*S.S. Murrumbidgee Sld. report No 14434*

# IRON MASTS

No 228 S.S.

## FORE MAST

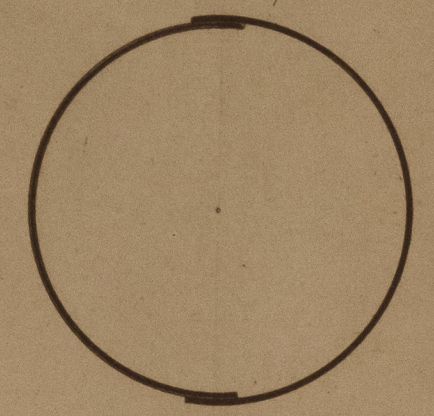
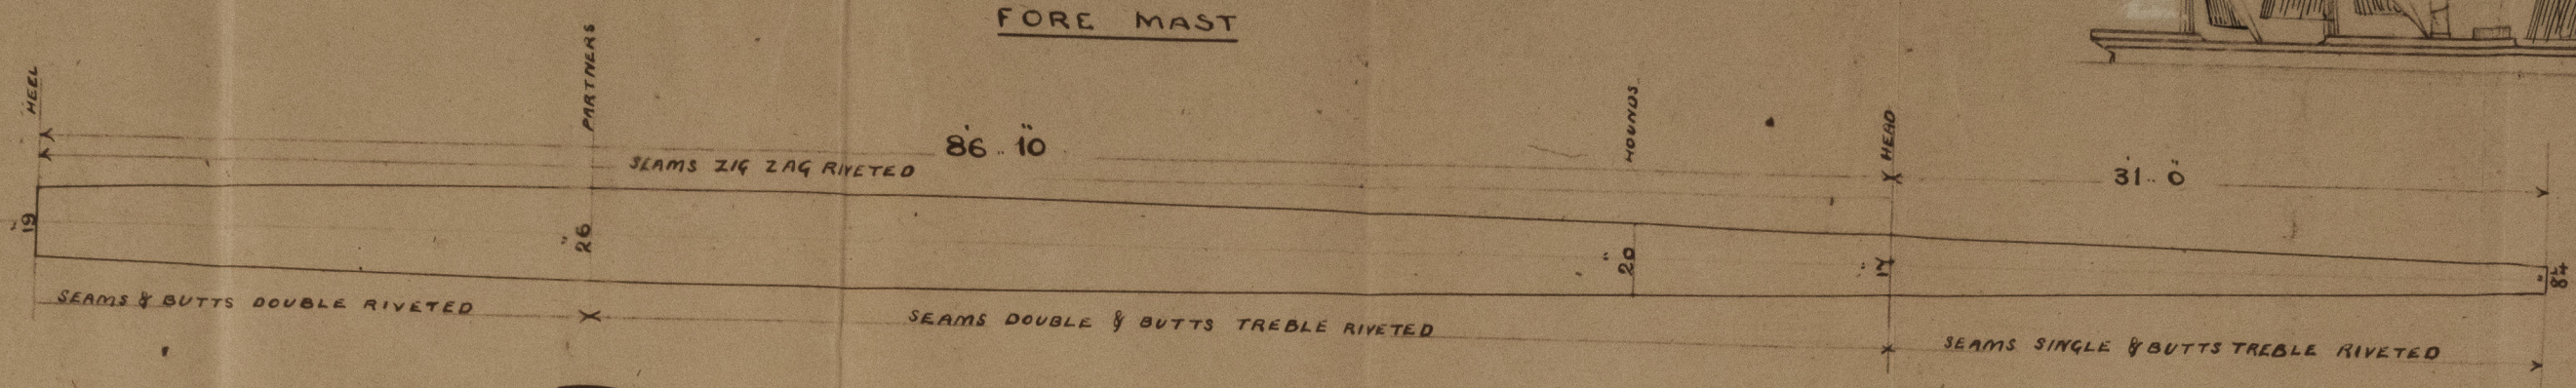
*Plating to be increased  
in thickness or 3 angles  
fitted.*

*Heels of masts to be efficiently strengthened.*
